West Torrens Local Area Traffic Management for Precincts 17, 18, 19, 20 & D

Thank you for the opportunity to comment on the latest LATM proposals for West Torrens.

Farnham Rd

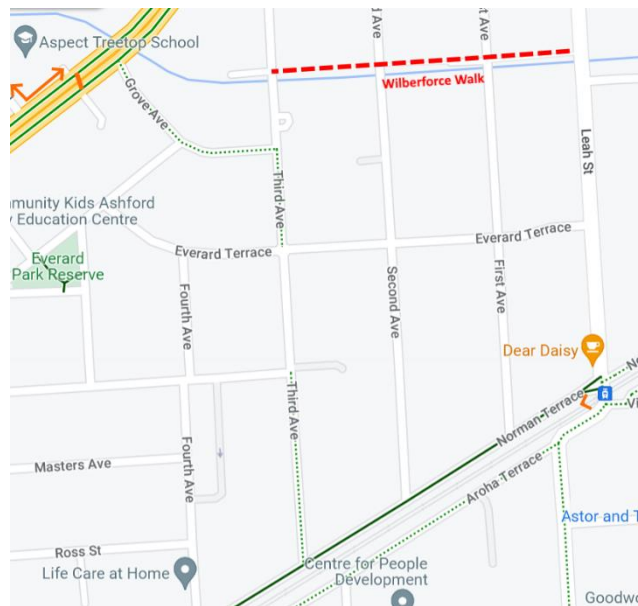
The Discussion Paper notes that although Farnham Road is the only north-south road that connects Richmond Road and ANZAC Highway, it is not considered to have any function beyond providing local access. Consideration should be given to acknowledging a cycling role for this road, related to routes in neighbouring Unley.

As shown in the map at right, Grove Ave/Third Ave (green dotted line) connect Anzac Highway south-east to the Mike Turtur Bikeway (solid green). Third Ave also connects Grove Ave to the recently constructed Wilberforce Walk shared use path (red dashes). A pedestrian refuge (orange line) is located in Anzac Highway slightly south-west of the Grove Ave connection, providing access to Aspect Treetop School – close to the southern end of Farnham Rd. Farnham Rd itself then provides a useful north-south route for local cyclists, as a “low stress” alternative to South Road on-road bicycle lanes. (This onward route is indicated by orange arrows.)

Further, Farnham Rd terminates at Richmond Rd close to the Keswick Creek alignment. There is potential for the SA Water upgrade of Keswick Creek to use space in the creek corridor to host an off-road Greenway route to the Airport.

Recognition of a cycling role for Farnham Rd would justify a small amount of paving of the South Road footpath fronting Aspect Treetop School, to improve cyclist connectivity. It may have other implications on how Farnham Rd is managed from a traffic perspective and this LATM.

Precinct 19, #46: McArthur Ave pavement bars and line marking

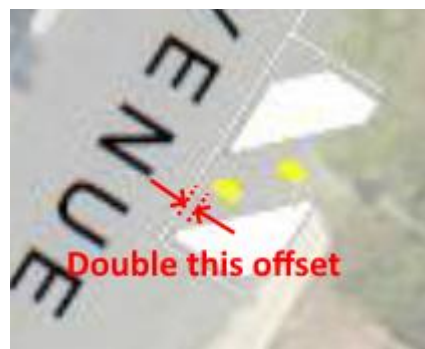
As noted, pavement bars can be a hazard for cyclists. Pavement bars in the centre of the road tend to force cars to occupy the lane when they come across a cyclist, rather than cross or straddle the centreline. While drivers should sit behind a cyclist until it is safe to pass, the reality is more frequently otherwise.

We therefore have concerns that the pavement bars circled in red would prevent a cyclist from moving out of the carriageway if they feel harassed by a following car, or that a car is passing too closely. An offset from the edgeline of at least twice that shown would be beneficial to cyclists.
